No.	Revision	By	Date
TOWN OF ADDISON DALLAS COUNTY, TEXAS MILDRED STREET IMPROVEMENTS PAVING STA. 0+00 TO STA. 5+00 GINN, INC. Consulting Engineers Dallas, Texas			
Designed - TEC	Drawn - TEC	Date - May, 1990	Job No. - 90439
Approved - HWG	Checked - GF	Scale - 1" = 20'H/1" = 5'V	Sheet M1 of 12

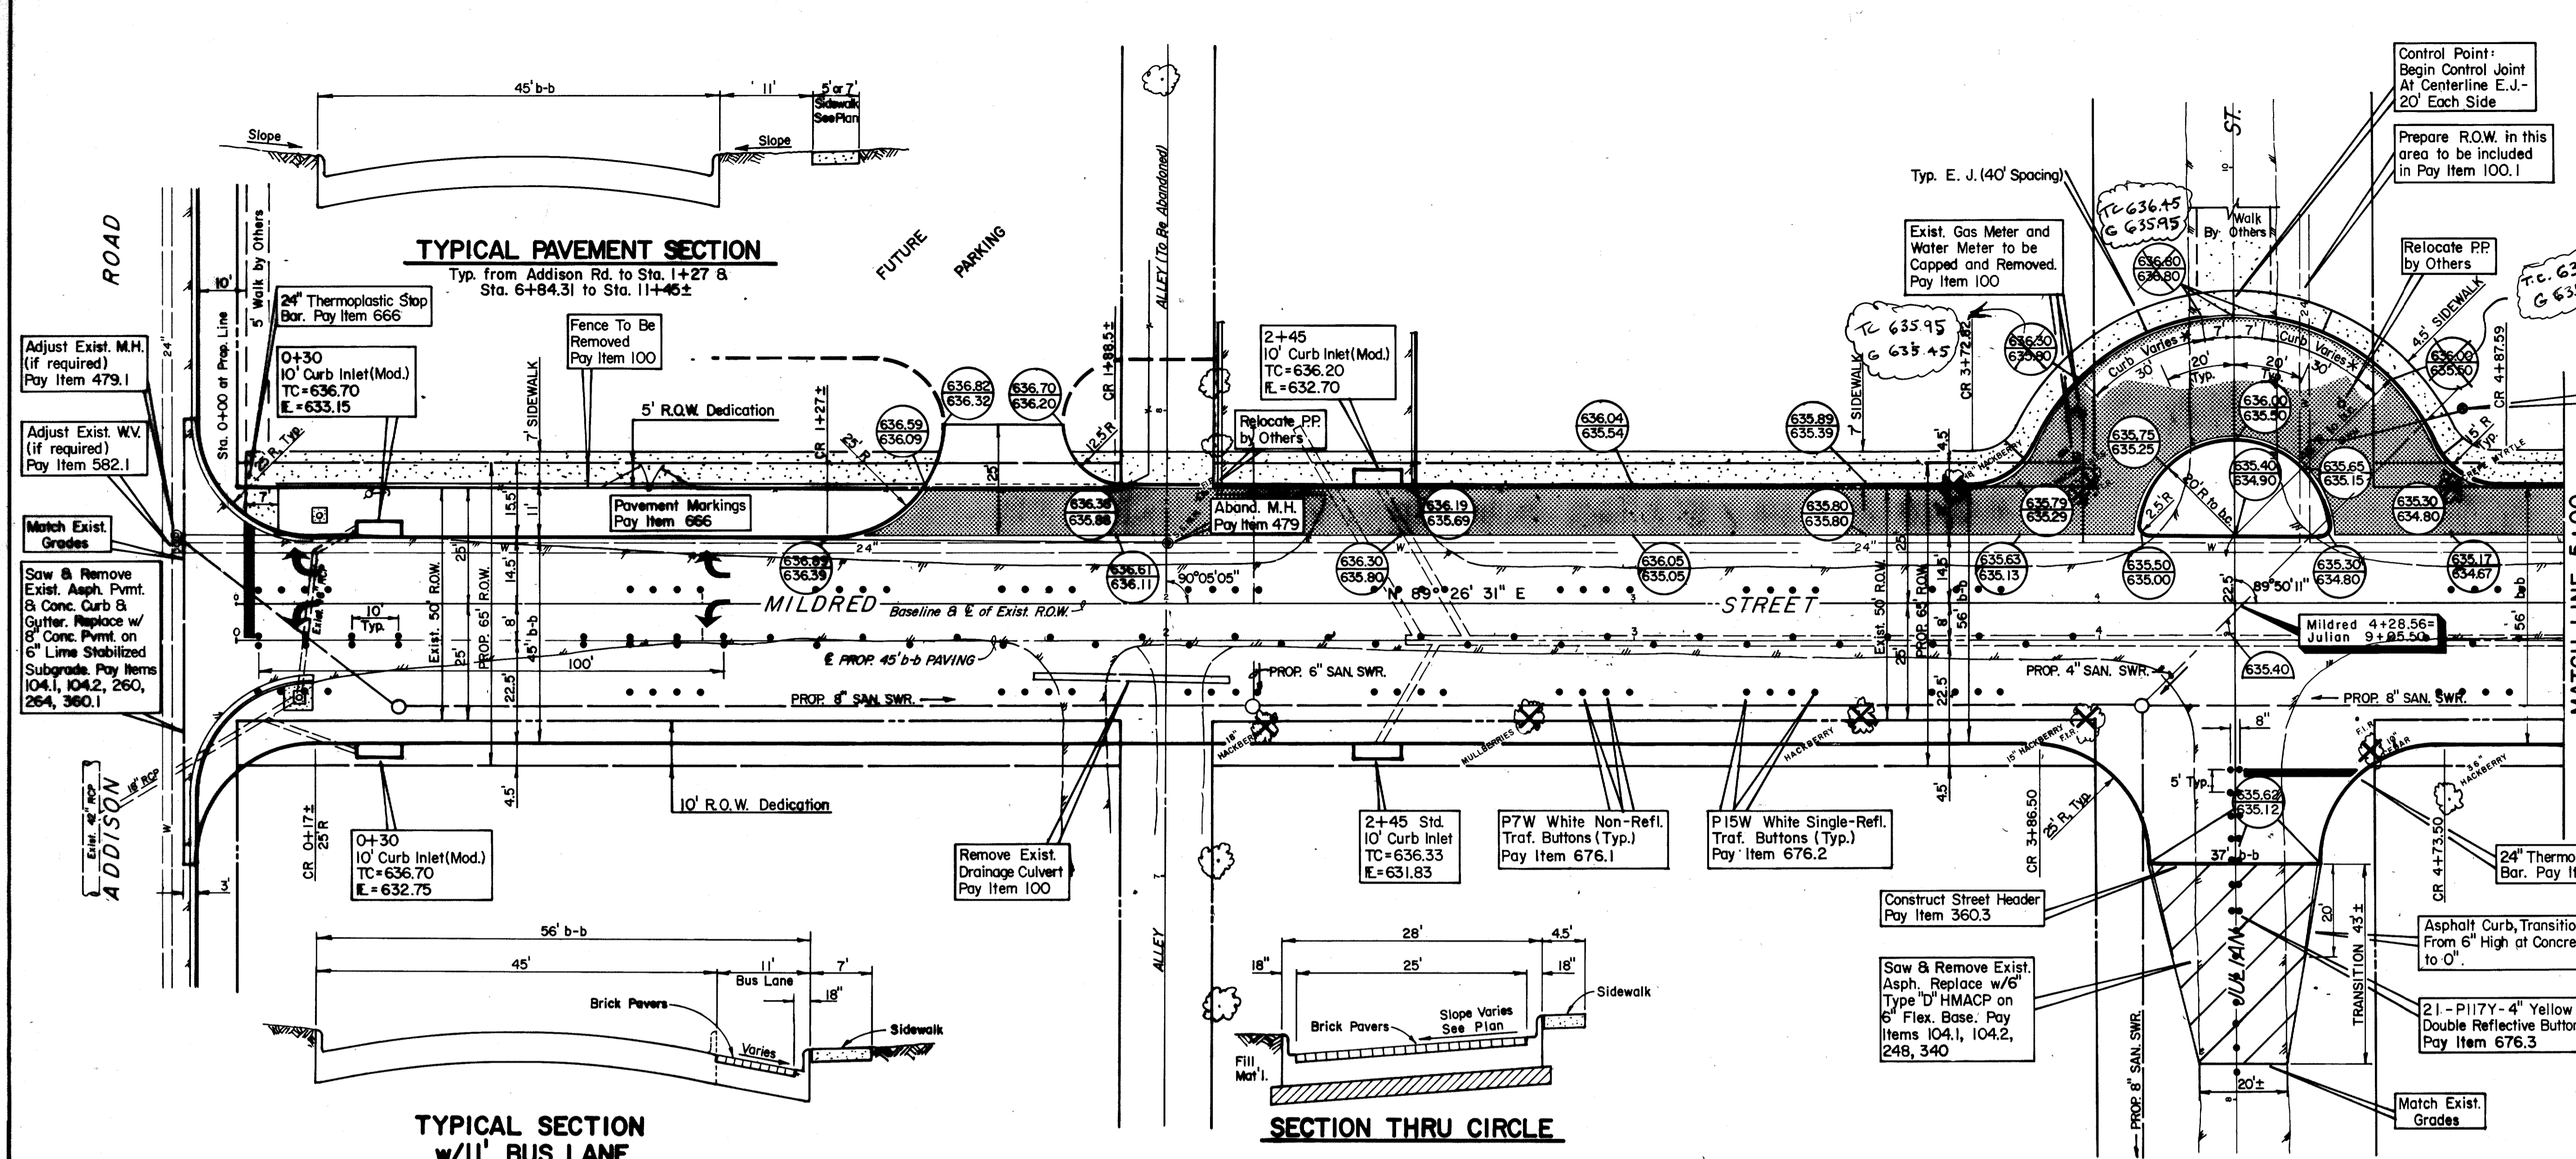
As per field change

Curb height varies from full 6\"/>

Relocate Exist. W.M. Extend Service w/3/4\"/>
